INDIANA DEPARTMENT OF TRANSPORTATION

# REVISED AGENDA

## September 17, 2009 Standards Committee Meeting

Revised Proposal to Standards Committee and Standard Drawings for Item  
No. 03 04/16/09 (2010 SS)

714-CCSP-01 THREE SIDED CONCRETE CULVERT SCOUR PROTECTION

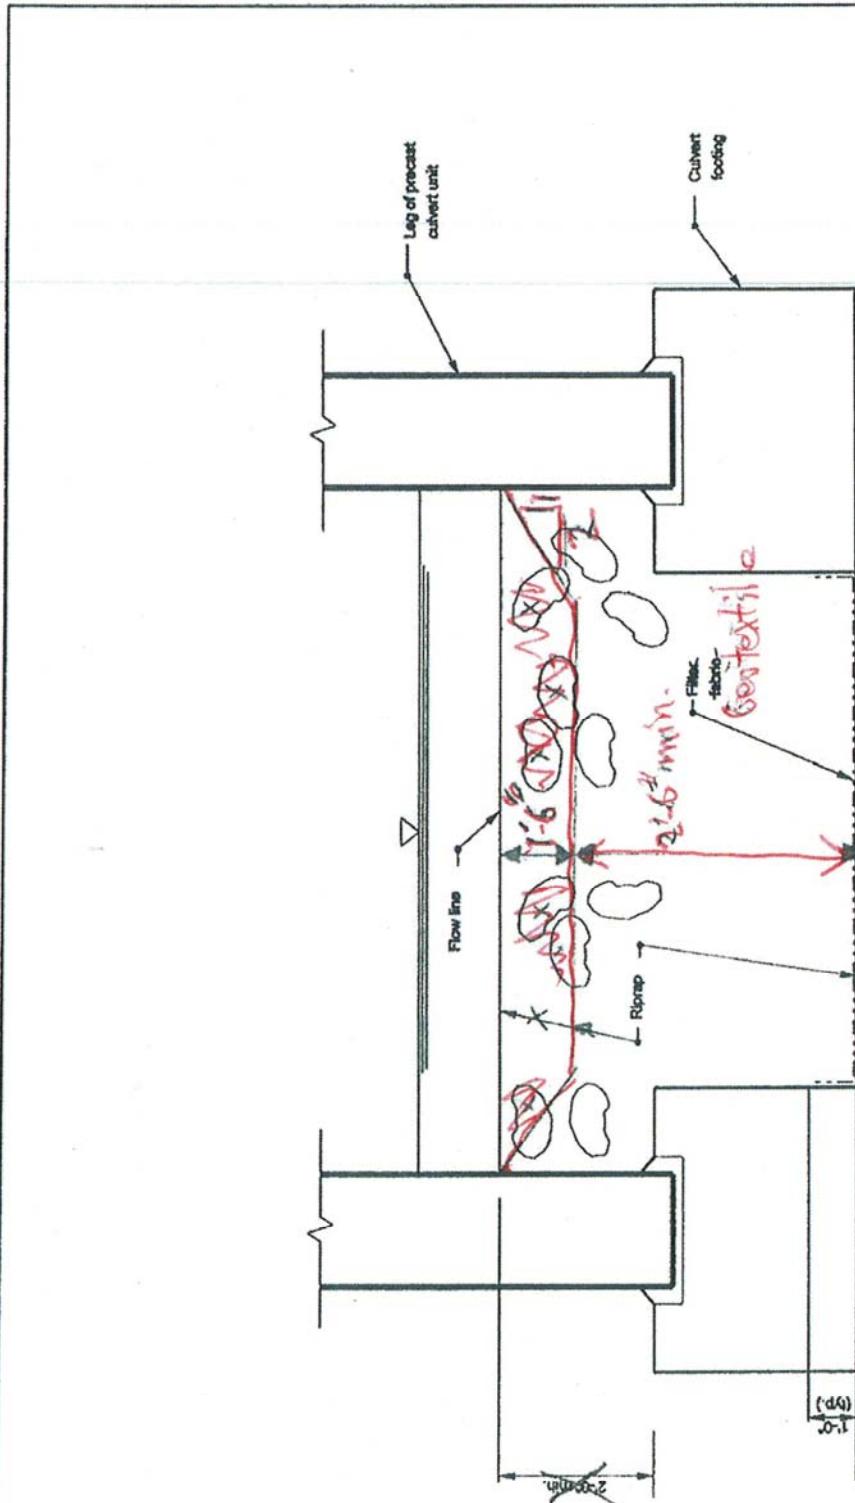
PROPOSED SOLUTION: Revise the Standard Drawings for three-sided-culvert scour protection to allow for passage of natural stream-bed material as required by IDEM. Standard Drawings 714-CCSP-01 through -05 are affected, with a new drawing added. The CCSP series will be numbered as follows:

New	Old	Drawing Subject
01	01	3-Sided, Riprap Method, Span at least 10' but less than 20', plan view
02	03	3-Sided, Riprap Method, Span at least 10' but less than 20', section view
03	01	3-Sided, Riprap Method, Span greater than 20', plan view
04	02	3-Sided, Riprap Method, Span greater than 20', section view
05	04	3-Sided, Base-Slab Method, plan view
06	05	3-Sided, Base-Slab Method, section view

**Standard Drawing E 714-CCSP-04**

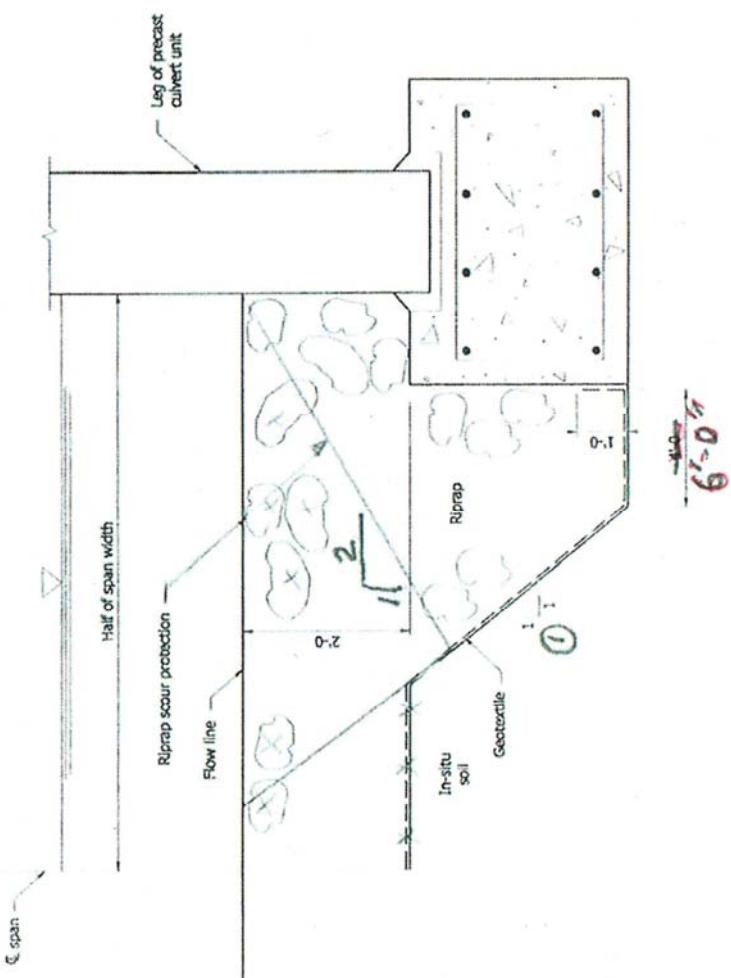
- Top of 4-11 slope**
- Bottom of 2:1 slope**
- 6' in front of footing**
- Bottom of 2:1 slope**
- 6' in front of footing**
- NO X HATCHED**
- Bottom of 1:1 slope**
- 6' in front of footing**
- Span width  $\geq 20'$**

714-CCSP-04 THREE SIDED CONCRETE CULVERT SCOUR PROTECTION

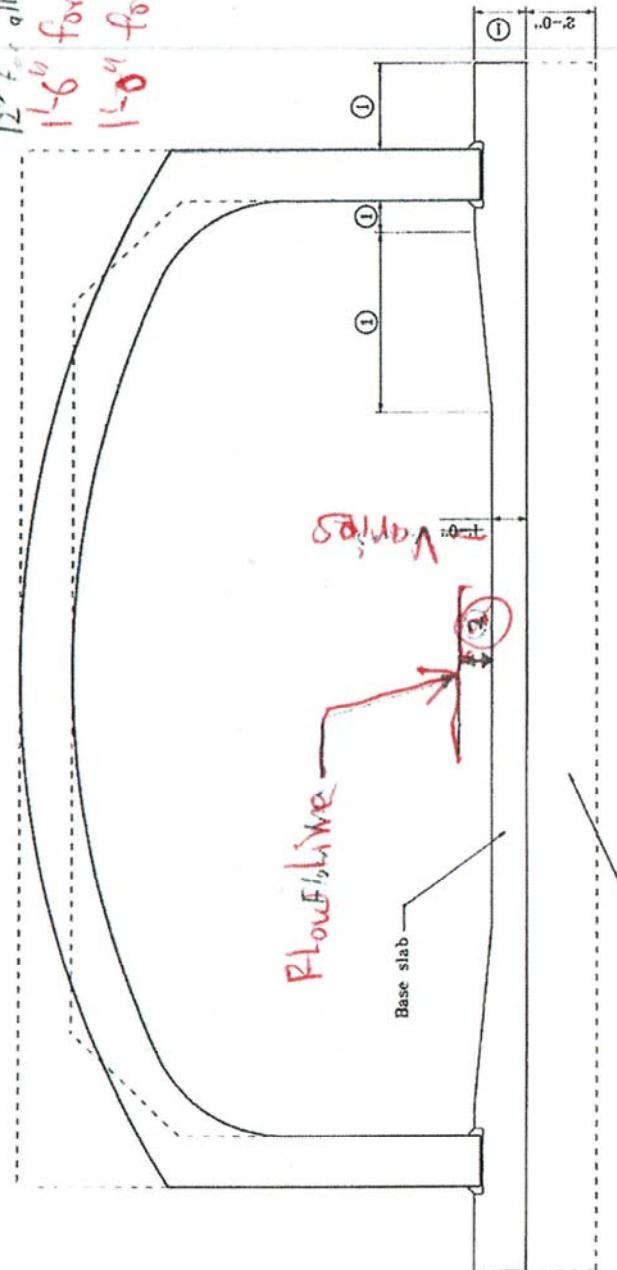
Toef of slope at steep depth

Toe of slope  
at sump depth

**714-CCSP-05 THREE SIDED CONCRETE CULVERT SCOUR PROTECTION**

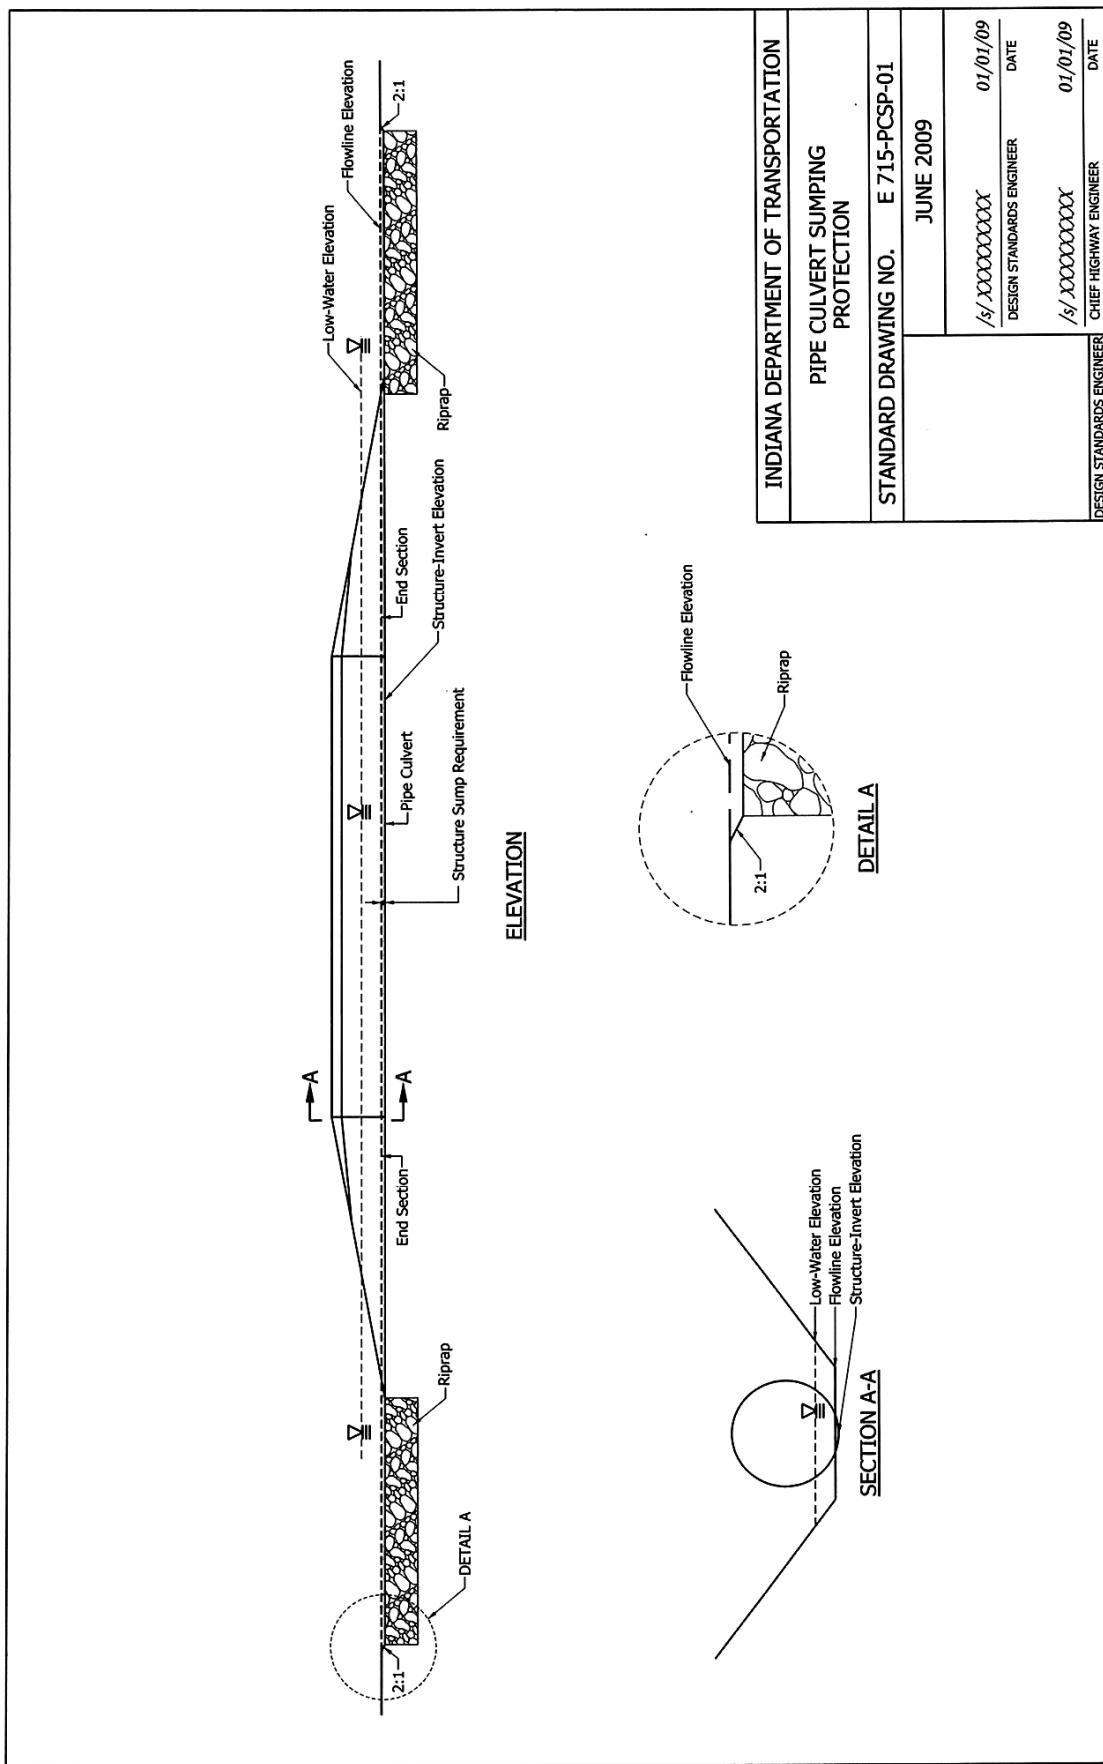
② 18' for sand-bed streams  
12' for all other bed materials  
1.6' for sand-bed streams  
1.0' for other bed streams
